Addendum #2
Issued March 24, 2026

Request For Bid B26-0226-05
Hoffard Pond and Mirror Pool Dredging

at
John A. Logan College

Addendum #2

SITE PLAN

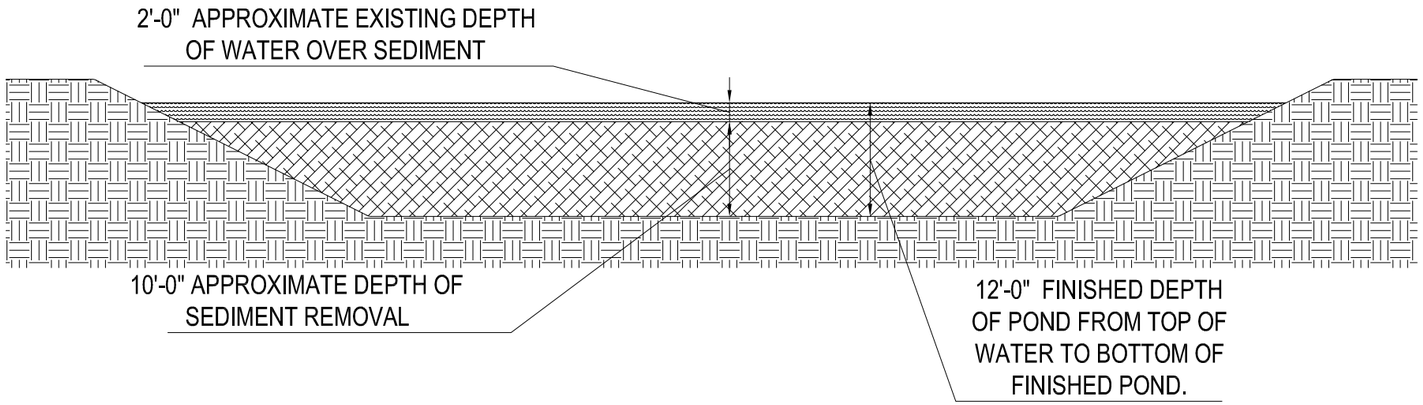
Q3: Is the intent of this project to remove the silt to the original pond bottom contours as shown on drawings?

Q4: If the drawings are not available, can you please provide the proposed contours on the pond after dredging?

A3: Yes. New drawings are provided with clarification.

A4a: The College would the pond contoured with the following specifications: 12ft deep, flat bottom, with 2:1 side slope. There is approximately 10ft of sediment to be removed from Hoffard Pond. Updated drawings are included as referenced in A2 above.

A4b: The Mirror pool depth is approximately 3.5ft with 2ft of sediment to be removed. Updated drawings are included as referenced in A2 above.
